NUREG/CR-3786
SAND84-0978
AN
Printed August 1984

A Review of Regulatory Requirements Governing Control Room Habitability Systems

Prepared for
U. S. NUCLEAR REGULATORY COMMISSION

Figure 1: Example of HVAC System Operating in the Smoke Removal Mode and Not Satisfying the Single Failure Criterion. For example, if either of the air intake or exhaust valves failed, the smoke purge capability would be lost.

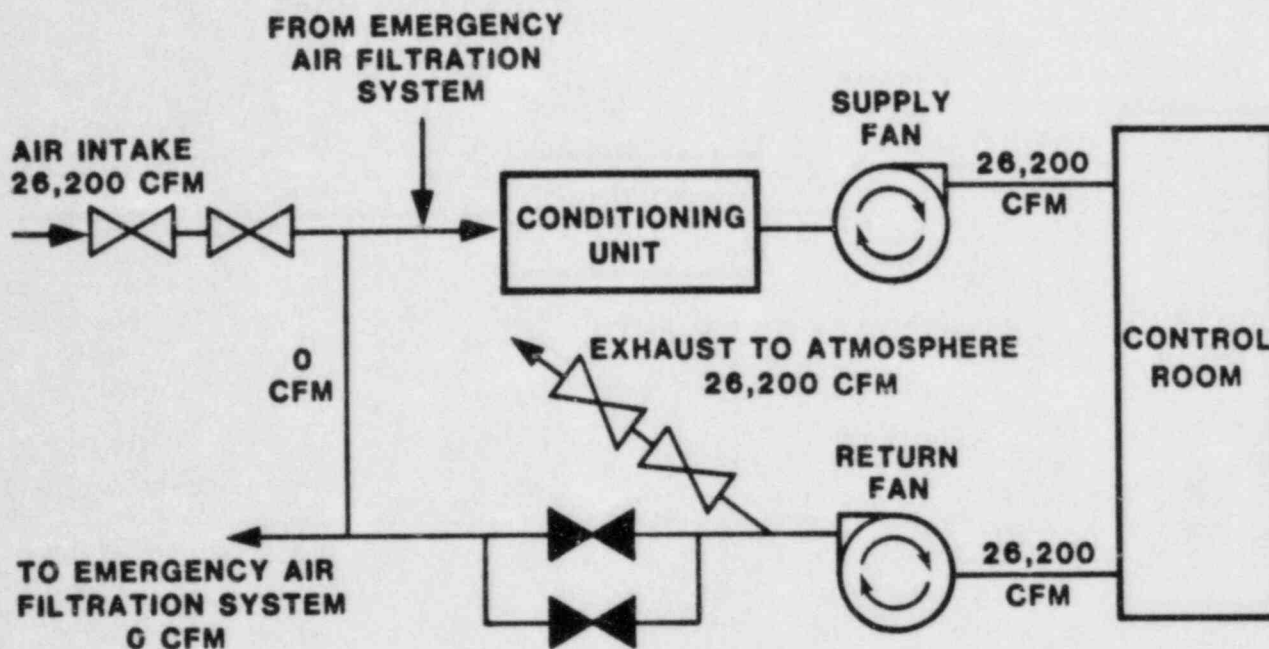
The single failure criterion is apparently not applicable to smoke removal systems because the normal ventilation system is not required as an ESF. Figure 1 shows an example of an actual design which does not satisfy the single failure criterion when the system is operating in the smoke removal mode. The failure of any one of the normal inlet or exhaust isolation valves, for example, would result in the closing of that valve (isolation valves fail closed) and the complete loss of smoke removal capability. Also, no guidance for sizing the system (i.e. smoke removal rates or number of air changes per hour) is given in the RG and BTP. A review of several plant designs (see Table 1) indicates smoke removal capabilities from almost none to more than 25,000 CFM, illustrating the wide variations in current systems and the need for some sizing basis for CR smoke removal systems.

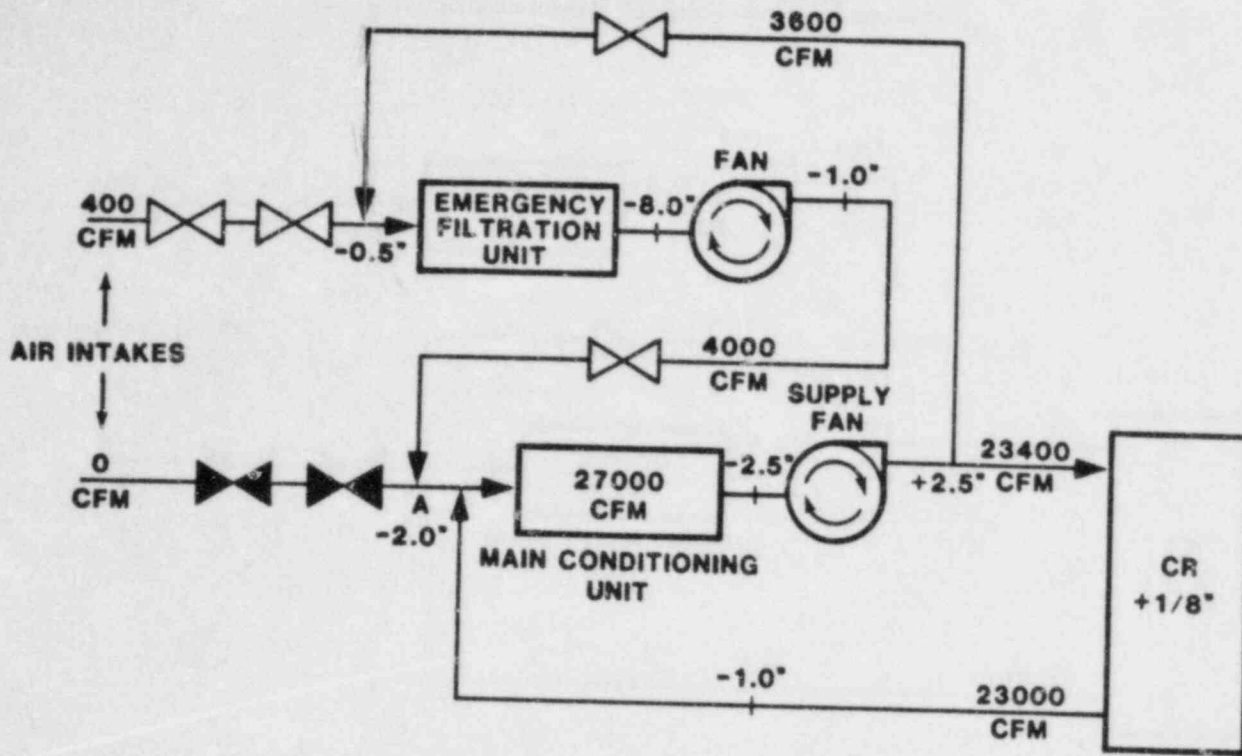
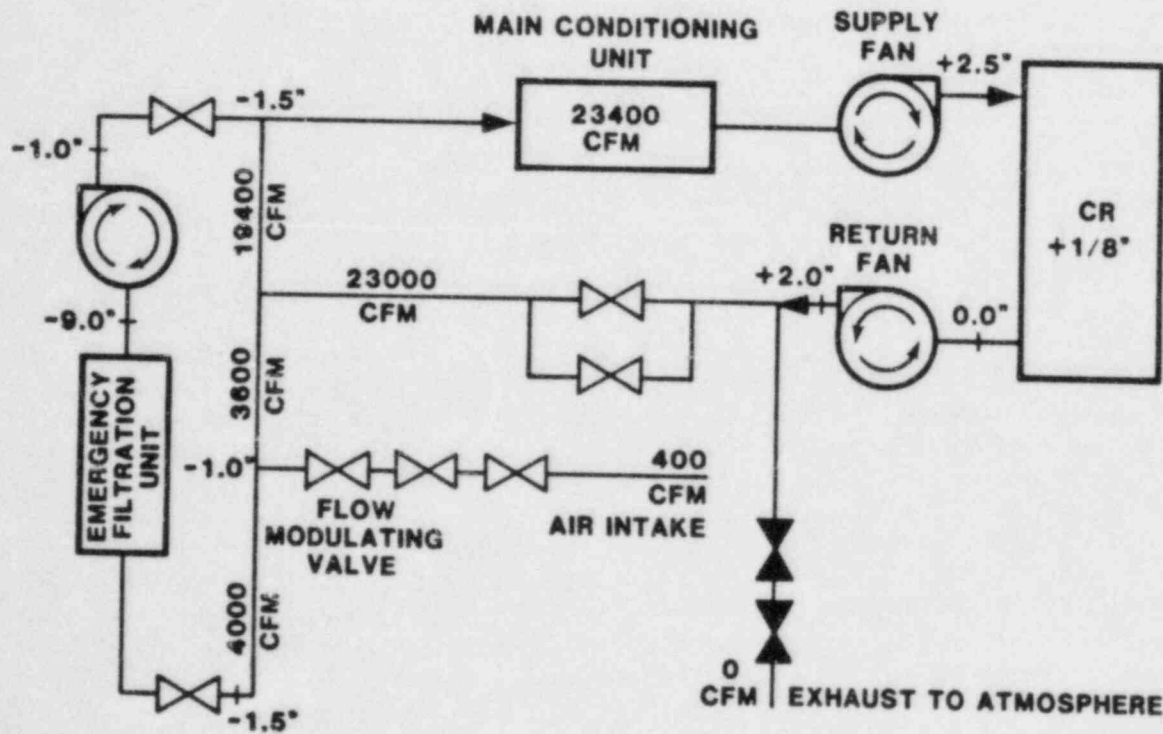
Figure 2 shows examples of a good system and a poor system, both operating in the pressurization/filtration mode, and both capable of meeting current system requirements. Typical approximate water gage pressures are shown for both designs. The design in Figure 2a has the advantage of only requiring two fans. However, with this configuration, the point labelled A is at a large negative pressure with respect to the atmosphere, thus promoting unfiltered inleakage through the normal air intake isolation valves. Also much of the ductwork is at a negative pressure with respect to ambient. The design in Figure 2b incorporates well-selected (based on pressure vs. flow characteristics) and well-placed fans to minimize unfiltered inleakage to the system. The return air fan is placed close to the CR to keep the negative pressure section of duct short. The normal air intake also functions as the emergency air intake by using a flow control valve to reduce the flow during emergency operation. Consequently, the potential for unfiltered inleakage is greatly reduced. During emergency operation with CR pressurization, intake air is desired. During CR isolation with filtered, recirculated air, leakage past the air intake isolation valves will be filtered before entering the CR. In both modes of operation, the filtered portion of the recirculated air is not cooled in the main conditioning unit, allowing better relative humidity control in the emergency air cleanup unit. Finally, the second design is much better suited for forced draft smoke removal. However, to meet the single failure criterion, it would require dual inlets and outlets and several more valves.

To prevent the regulations from becoming overly prescriptive and causing a loss of creativity in design, system configuration could be covered in the review process. SRP 9.4.1 (15), which covers the review process for the CR HVAC system, is briefly described in Appendix A. This section should include specific review procedures to evaluate system configurations.

Figure D-1: Comparison of Three Different Linear Approximations (AA, BB, and CC) to a Gaussian Curve (DDD)

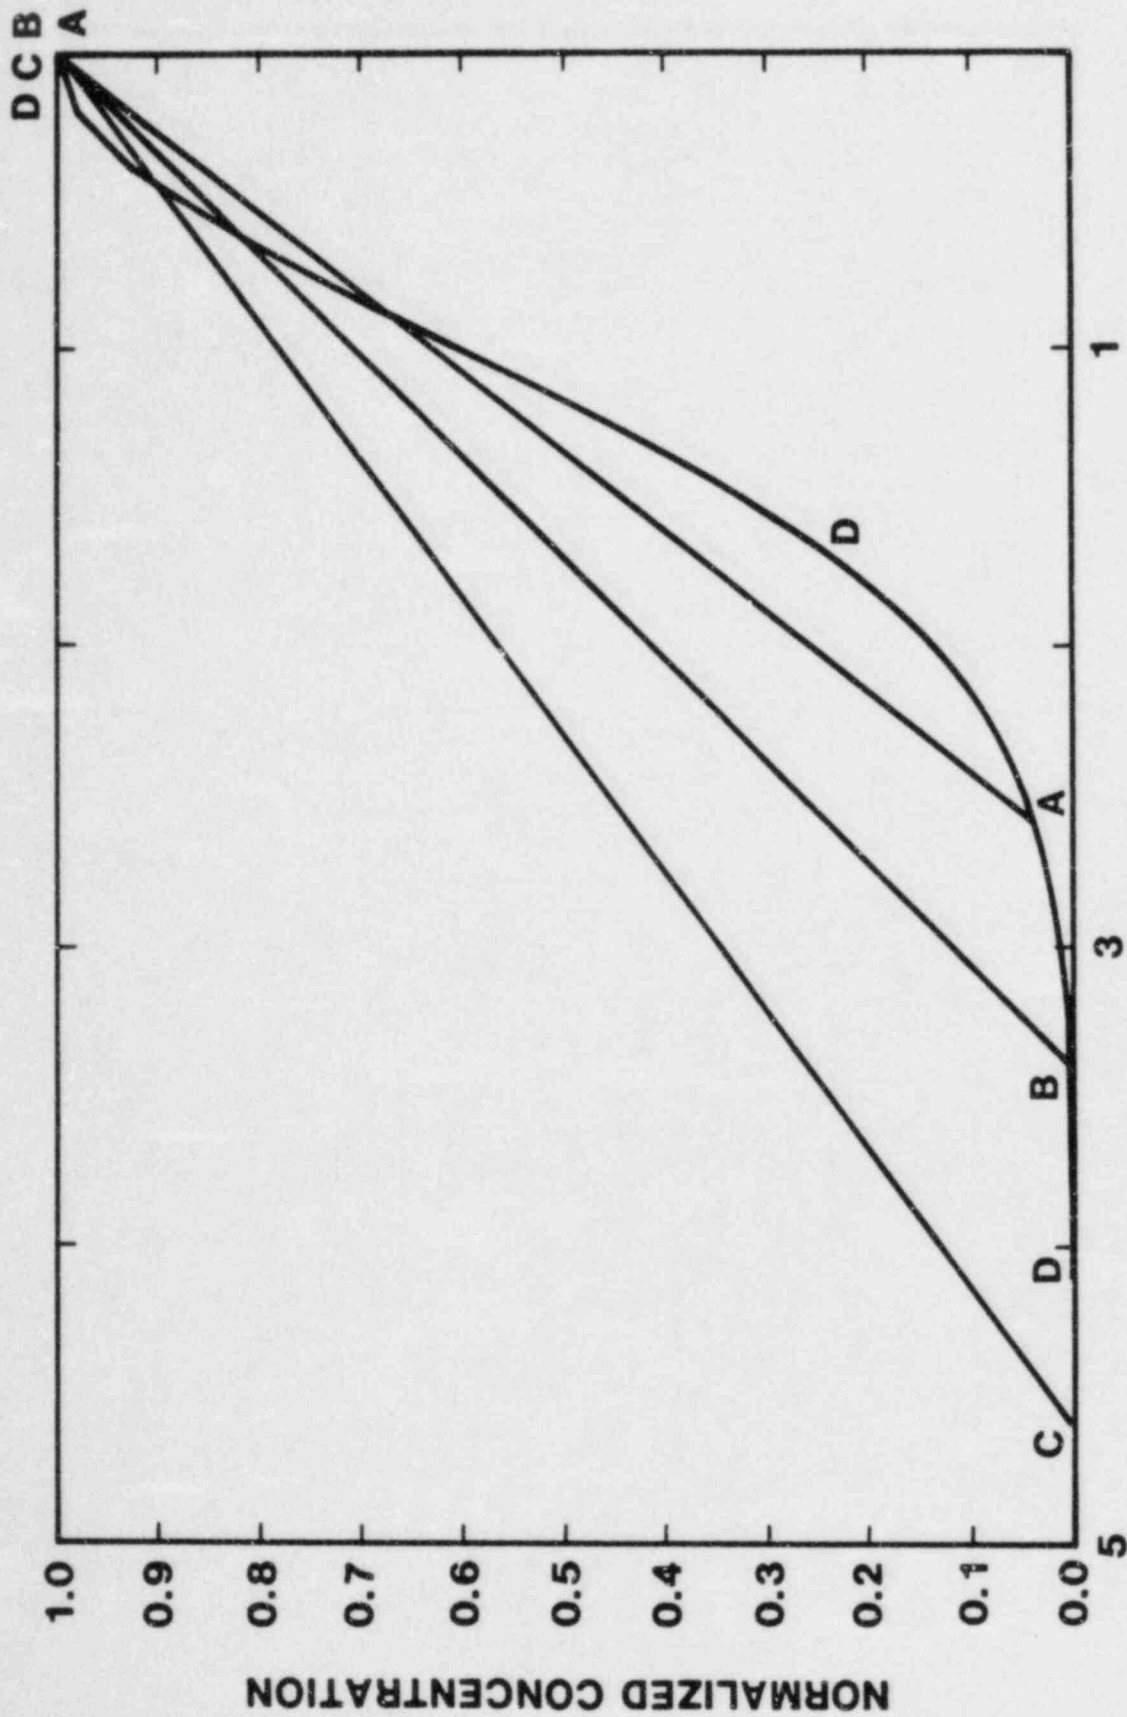
In all cases, the NRC method assumes a linear buildup of outside concentration from 5 ppm to the peak value. This assumption is an approximation to the more realistic Gaussian concentration distribution with both an increasing and a decreasing interval of outside concentrations. The linear buildup assumption conservatively approximates only the front half, or increasing part of the distribution; it ignores the back half, or decreasing part of the distribution and therefore becomes non-conservative after the peak concentration passes the air intake.

When using equations B-2 and B-4 in Appendix B, the important factor governing the inside concentration is the time average concentration outside the CR. The passage of the whole puff (from a given concentration on the increasing side of the curve to the same concentration on the decreasing side of the curve) within the isolation time would result in a time average concentration exactly equal to the time average concentration resulting from passage of only half the puff during the isolation time (from the given concentration to the peak concentration). However, passage of greater than one half the puff, but less than the whole puff, will result in higher time average concentrations than passage of the whole puff.

To illustrate the effects of the linear approximations, Figure D-1 shows a comparison of the front half of a Gaussian curve and three possible linear approximations to this curve, typical of those used in the calculations. The actual linear approximation which is inherently used in the method varies with the quantity released, the distance of the source from the CR, and the equations above which govern the values in Table 1 of RG 1.95 (8). When using equation B-4, a very conservative result in the allowable chlorine inventory results because of the two related assumptions that the initial standard deviation of the puff is zero and the Pasquill Stability Criterion is Type G and because the linear approximation to the Gaussian curve becomes very conservative. When using equation B-2, the linear approximation is similar to line AA or line BB on Fig. D-1; when using equation B-4, the concentration is assumed to follow a line similar to line CC, but not necessarily all the way to the peak concentration since the windspeed is limited to 7 m/s when using equation B-4. The beginning part of the line CC approximation is especially conservative with respect to the actual case.
